Agenda

Planning and Zoning Commission Tuesday, March 4, 2025 at 7:00 PM Council Chambers

**RE: Meadow Brook Preliminary Plat, Hutto, TX 78634
Plat Review – Meadow Brook Preliminary Plat - Comment Report to Initial Submittal (received 2-4-25)
Project No.: PLAT-24-0038**

RE: Ironwood Subdivision Amended Plat, Hutto, TX 78634
Plat Review – Ironwood Subdivision Amended Plat - Comment Report to Initial Submittal (received 1-28-25)
Project No.: PLAT-25-0003

COVER SHEET

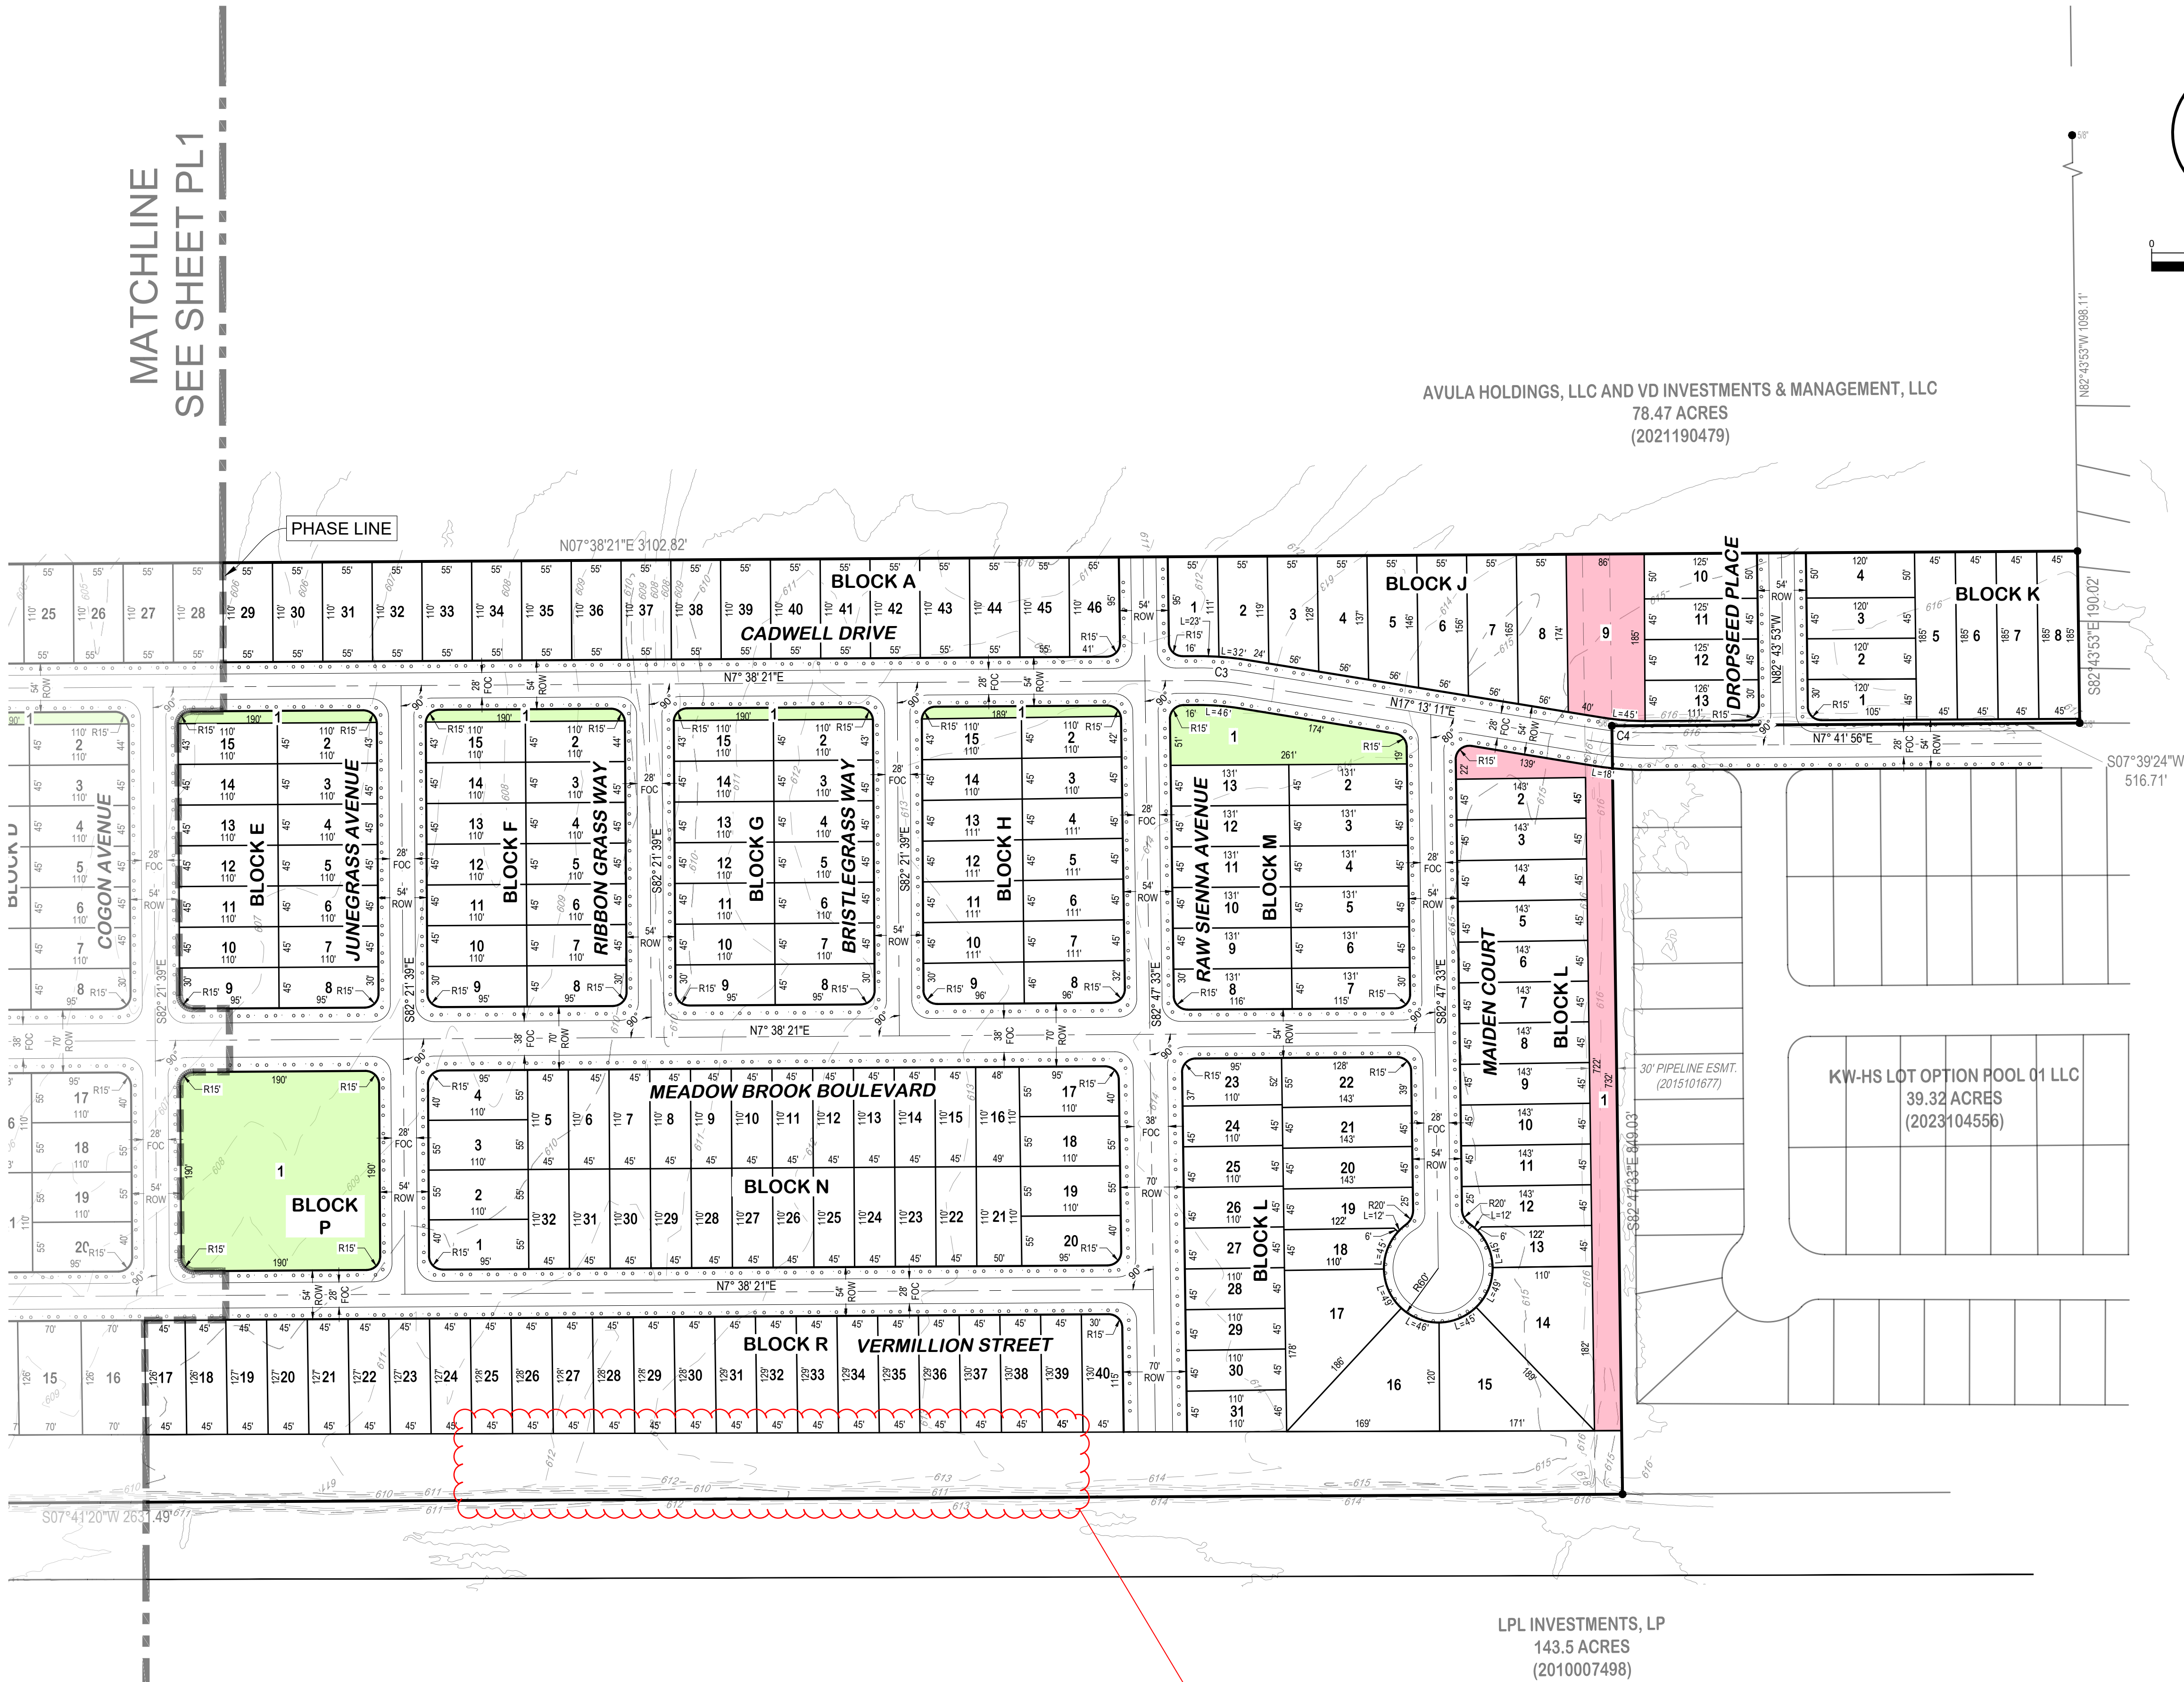
the PUD seems to indicate a commercial lot in this area. please clarify.

suggest showing these on the map for clarity and remove the notes. based on these notes, Lot 9 Block A, Lot 1 Block B, Lot 1 Block C, Lot 1 Block D, Lot 1 Block E, Lot 1 Block F, Lot 1 Block G and most of Lot 17 Block A become PUEs rather than parks.

LOCATED IN THE CITY OF HUTTO AND BEING OUT OF
THE MARTIN STROUSE SURVEY, ABSTRACT NO. 587,
WILLIAMSON COUNTY, TEXAS
SHEET 2 OF 9

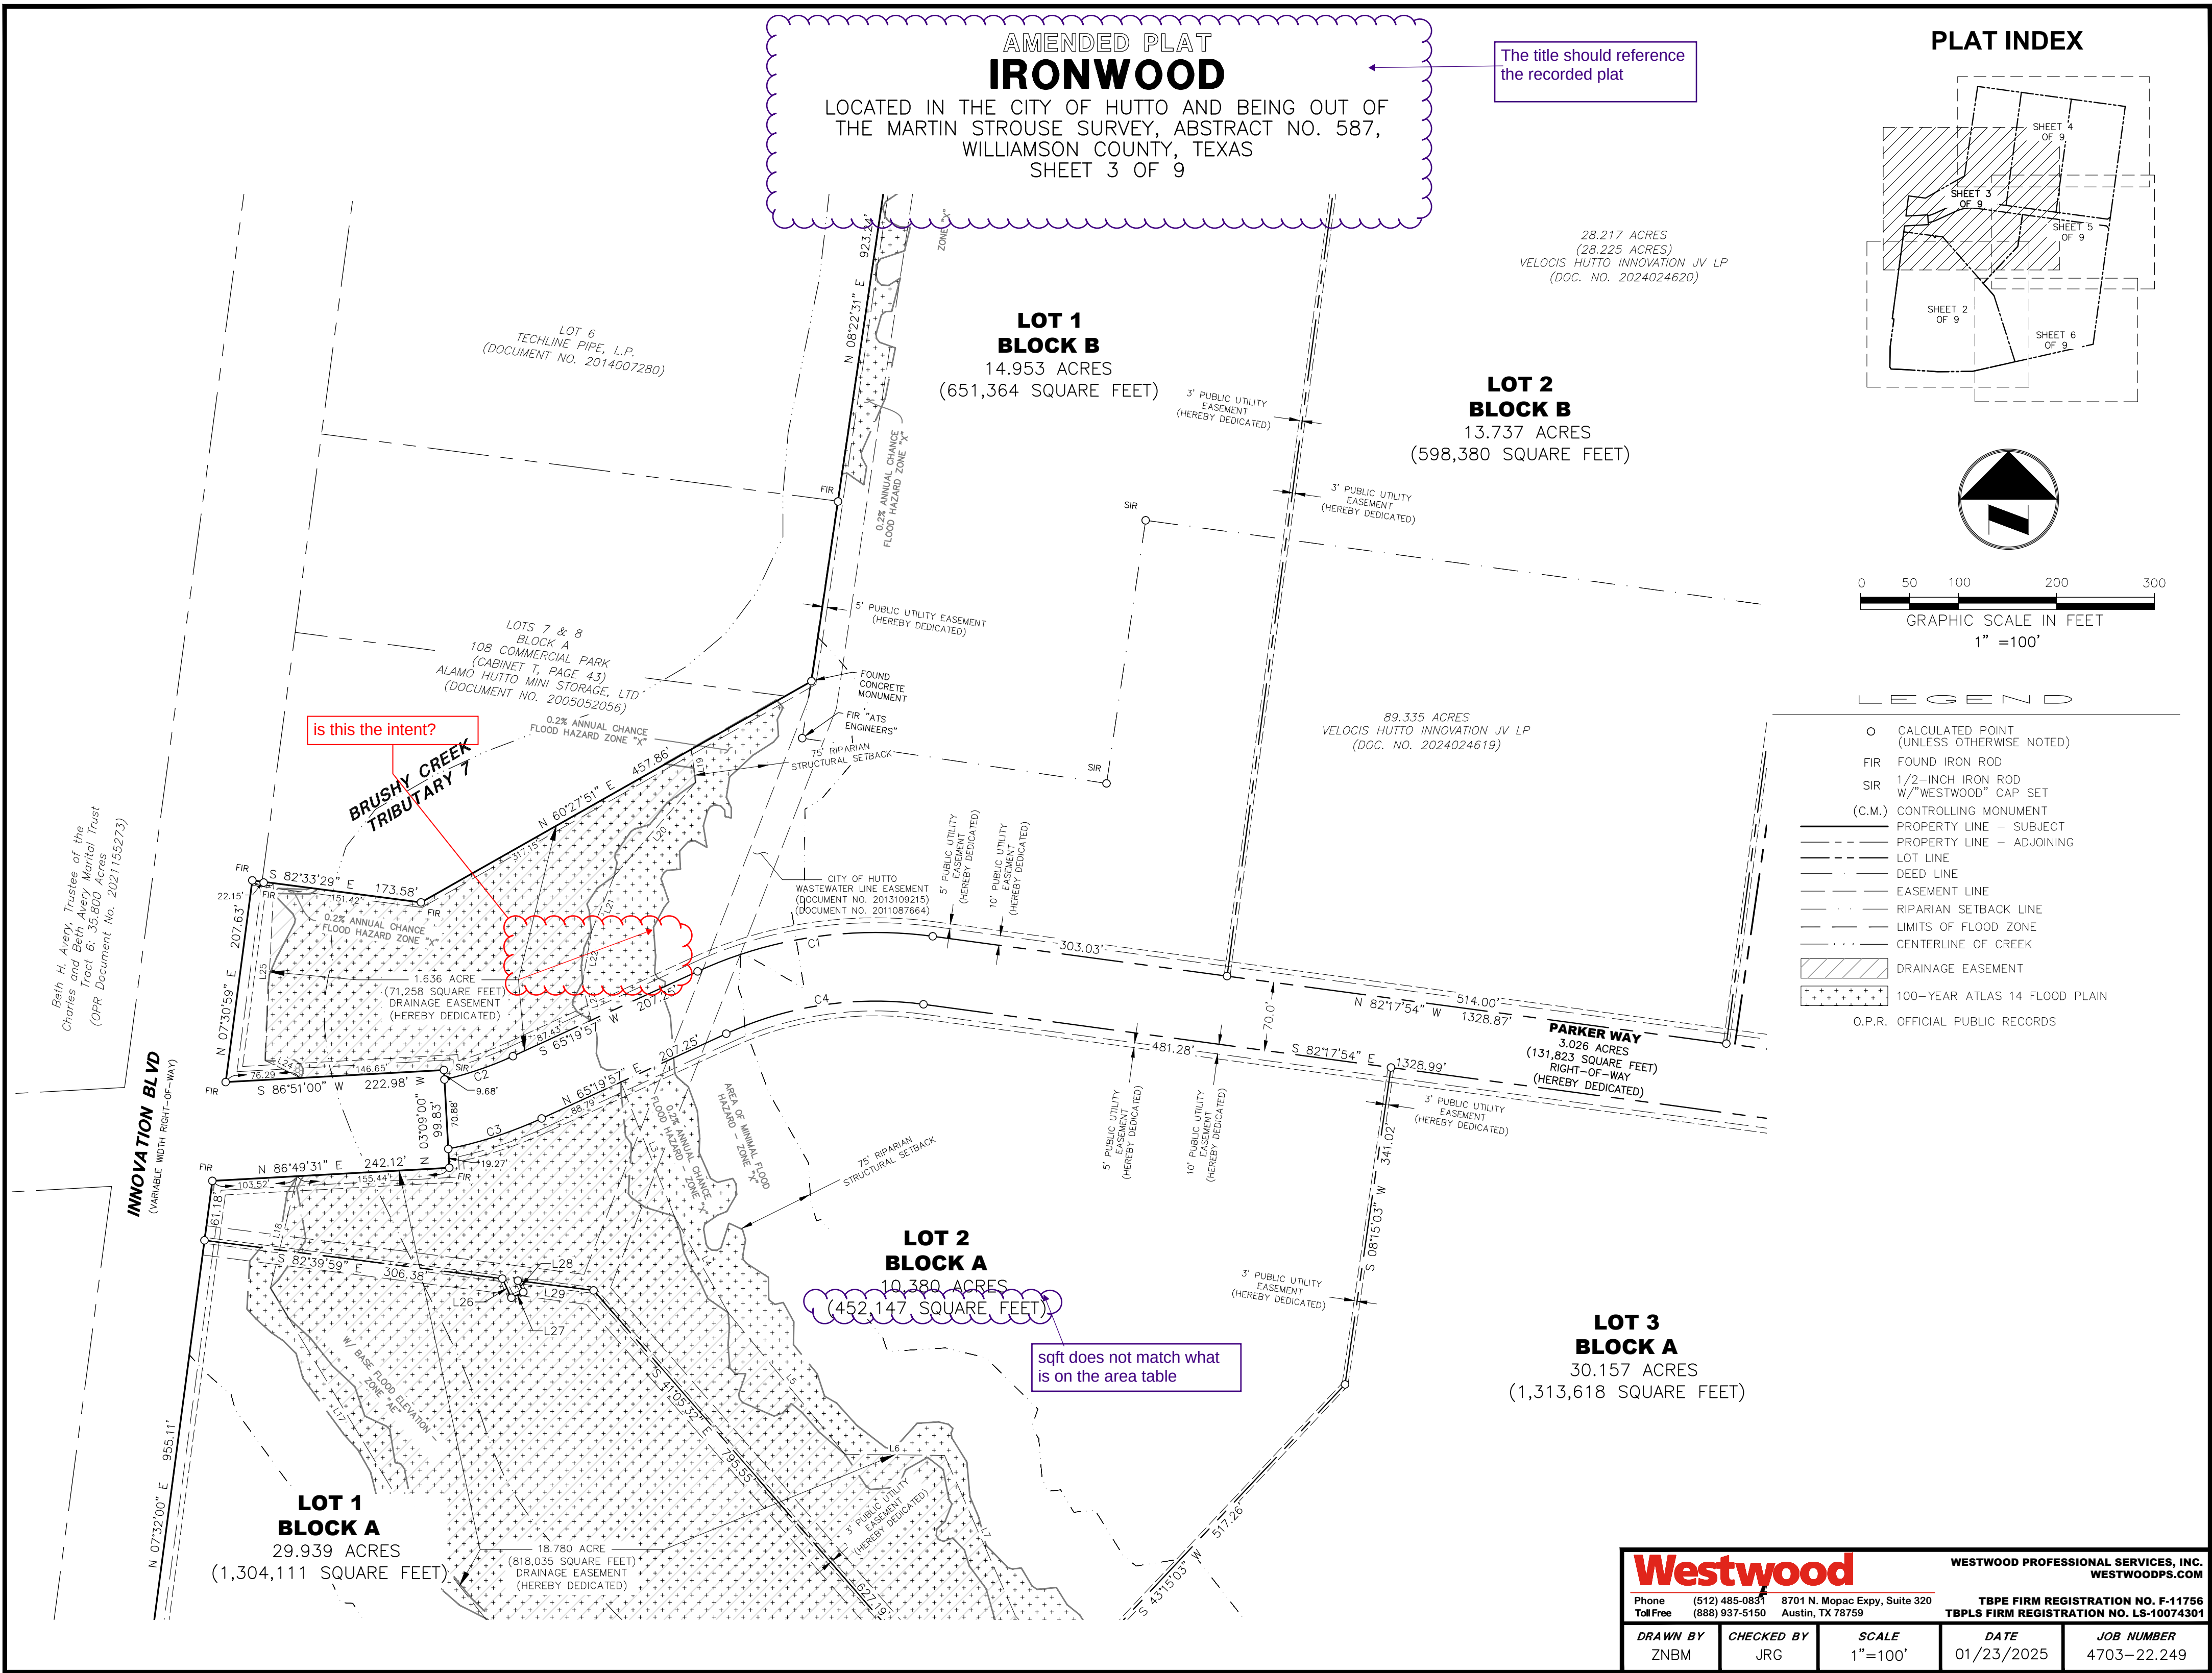
sqft does not match what
is on the area table

The title should reference the recorded plat

is this the intent?

Pre-Development Hydrologic Model

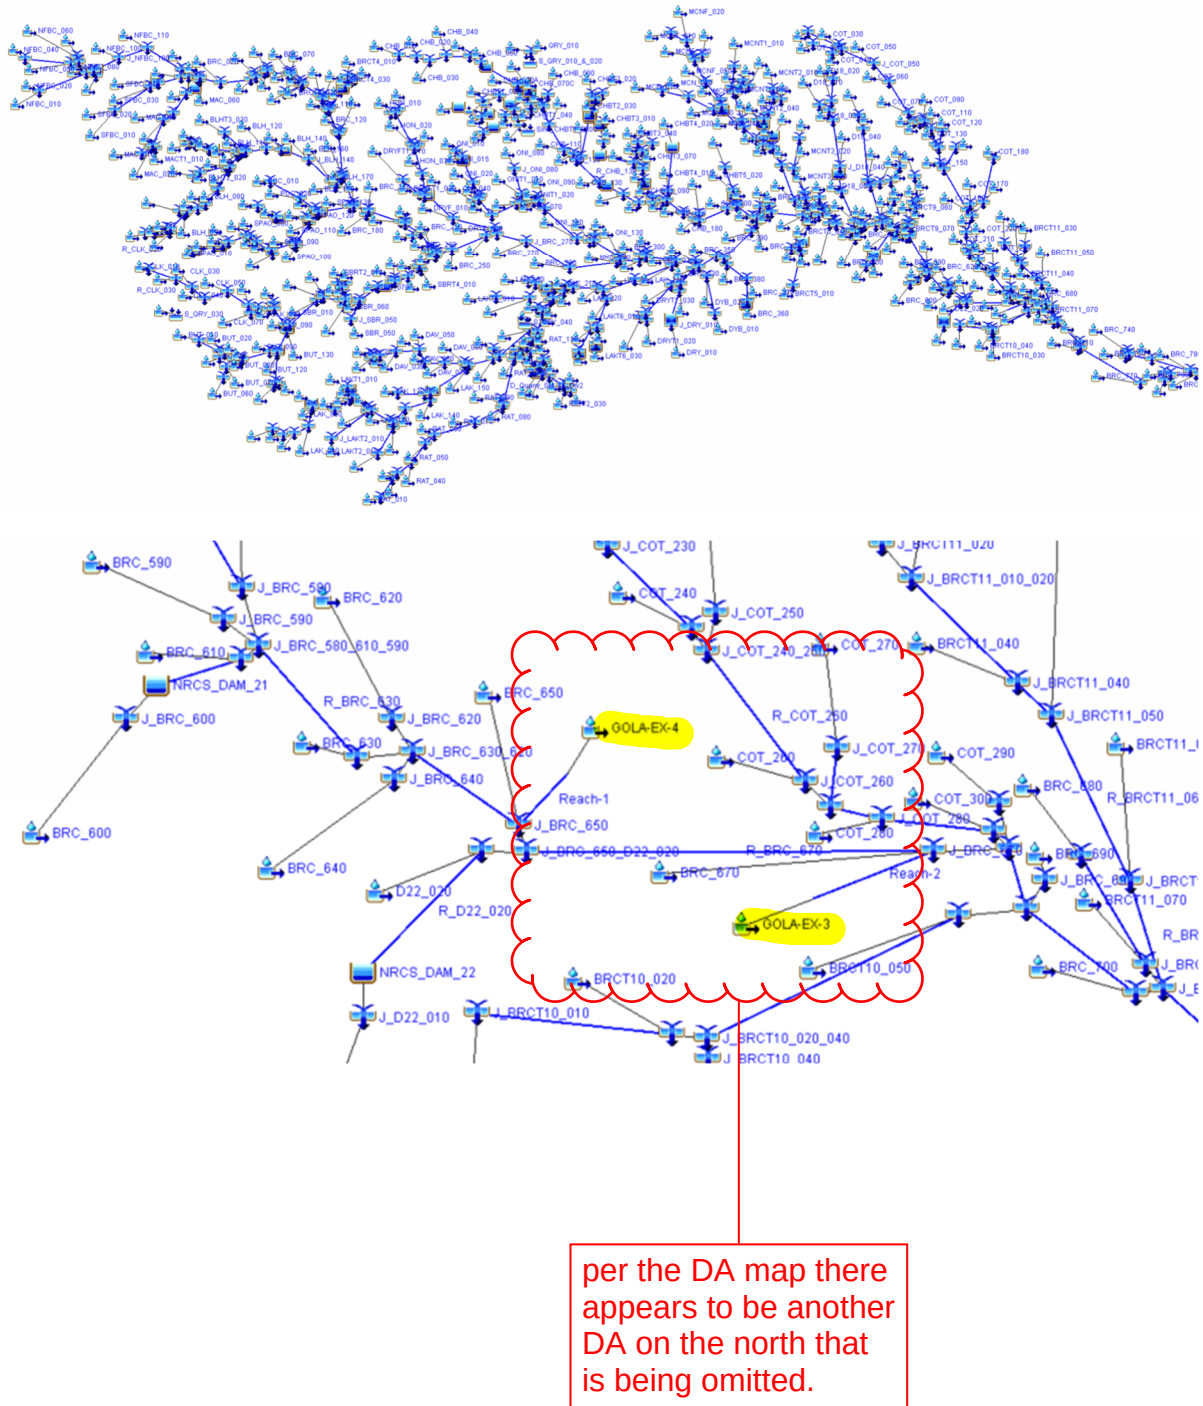
understood, however, there still appears to be a DA on the north that is being omitted.
